# 122-124 Graham Avenue Lurnea NSW 2170

Development Application for a Two into Three Lot Torrens Title Subdivision, Construction of two new Dwellings and Alterations to existing dwelling to include part demolition

### LETTER OF RESPONSE TO STATEMENT OF FACTS AND CONTENTIONS FOR PROPOSED RESIDENTIAL DEVELOPMENT AT 122-124 GRAHAM AVENUE, LURNEA

**ANNEXURE A: UPDATED PLANS  
(1 SHEET)**

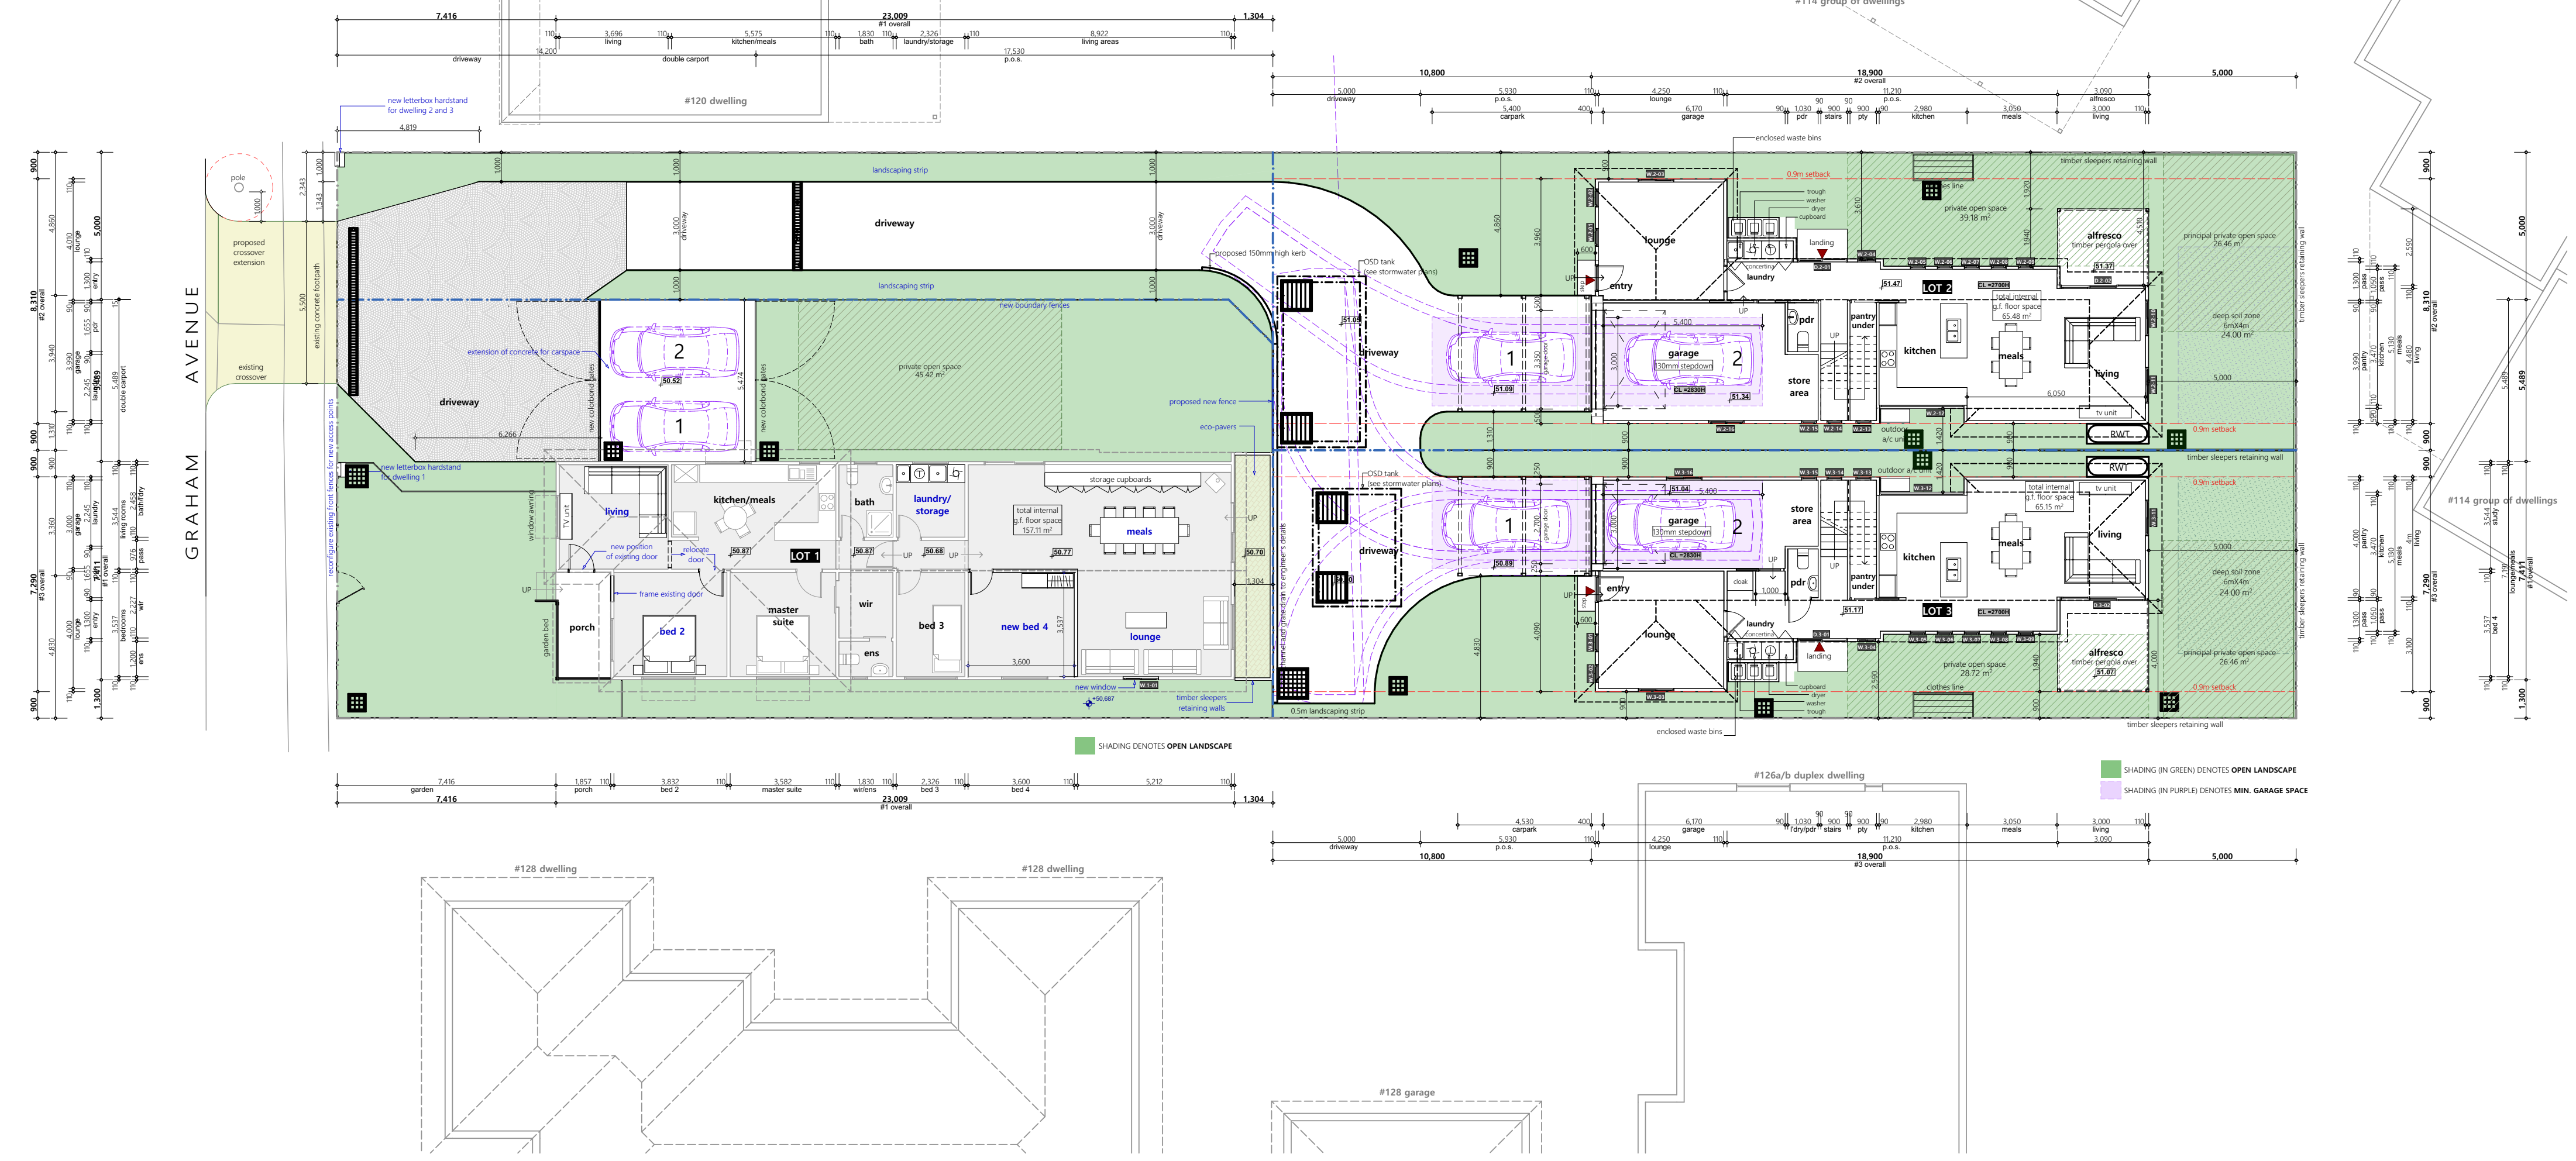
**MTE Response:** The vehicular crossing has been amended to align perpendicularly with Graham Avenue while maintaining a minimum width of 5.5m. The driveway is now located 1 metre from the power pole and therefore relocation of the power pole is unnecessary. The amended vehicular crossing is shown in **Annexure A**.

Nevertheless, the updated plans detail a minimum width of 5.5m for the first 6m of the vehicular crossing in compliance with Council's preference. The swept path testing in **Annexure B** demonstrates the successful two-way passing of two B99 design vehicles. This goes beyond standard requirements to demonstrate successful two-way passing at the vehicular crossing. AS 2890.1 – 2004 states that “Areas in which it is necessary for two vehicles to pass one another shall be designed for a B85 vehicle to pass a B99 vehicle”.

**B99 passing B99 within property boundary  
SUCCESSFUL**

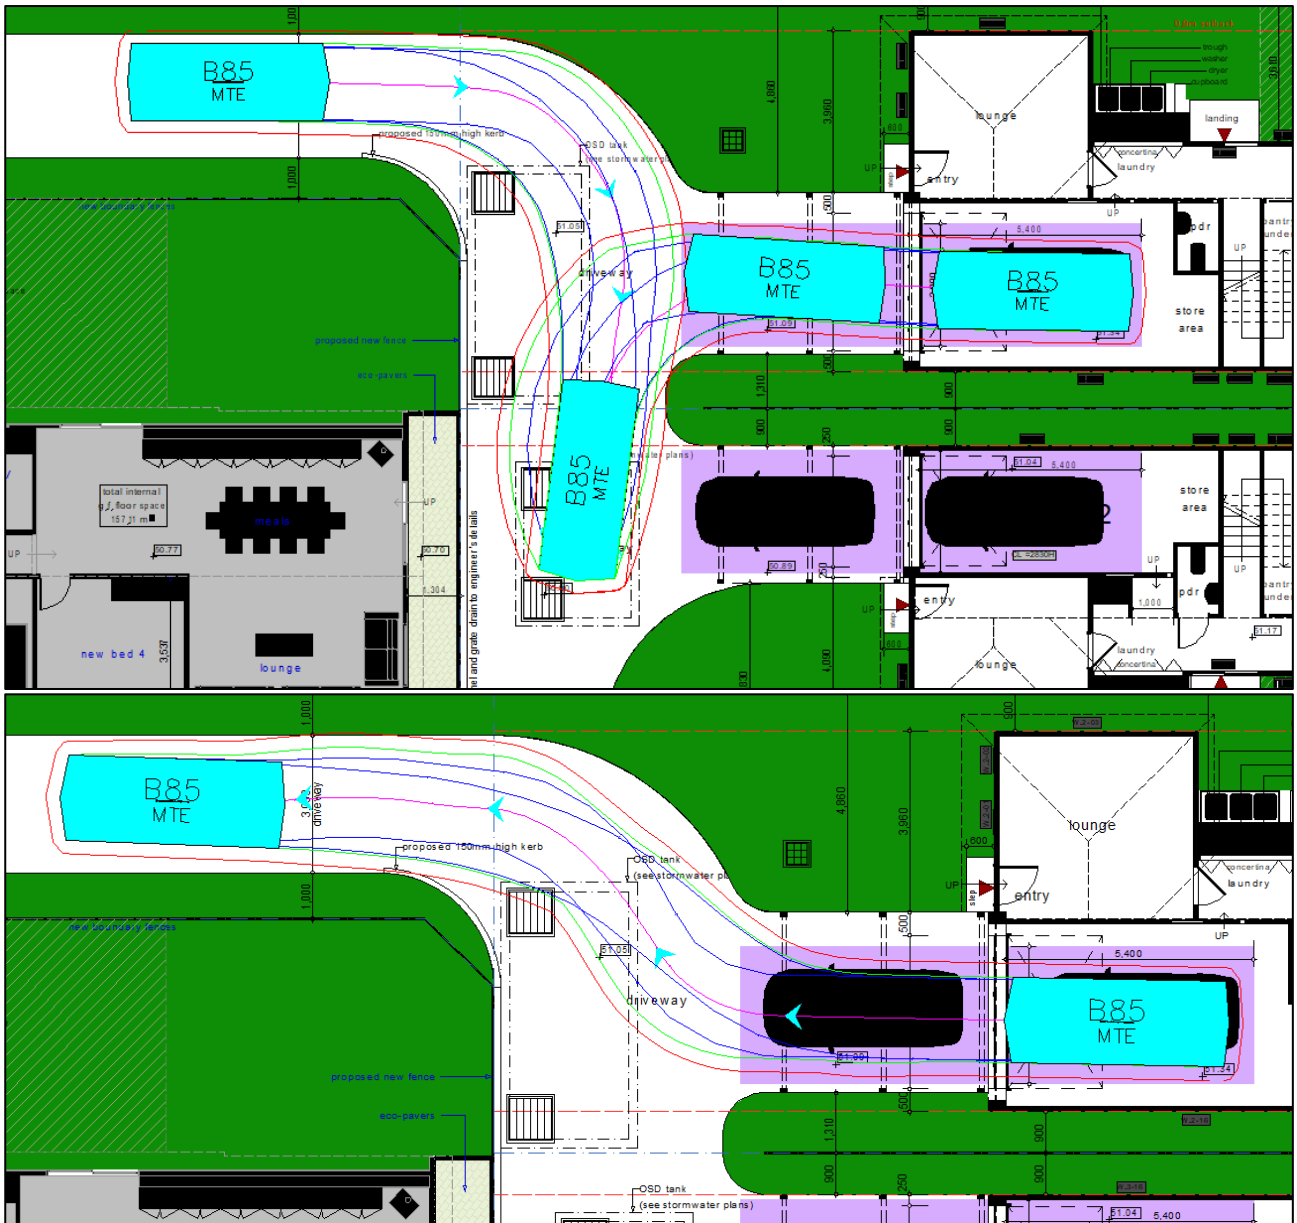
**MTE Response:** As outlined above, it is standard for swept path analysis diagrams to demonstrate two-way passing between a B85 and a B99 vehicle rather than two B99 vehicles. Clause 2.5.2 (c) of AS 2890.1 – 2004 states that “*Areas in which it is necessary for two vehicles to pass one another shall be designed for a B85 vehicle to pass a B99 vehicle*”. It is reiterated that it is usual and standard for swept paths to demonstrate two-way passing between a B85 and B99 vehicle for most development types. Nevertheless, the swept path tests reproduced in **Annexure B** demonstrate successful two-way passing on-site of two (2) B99 vehicles, satisfying Council’s request.
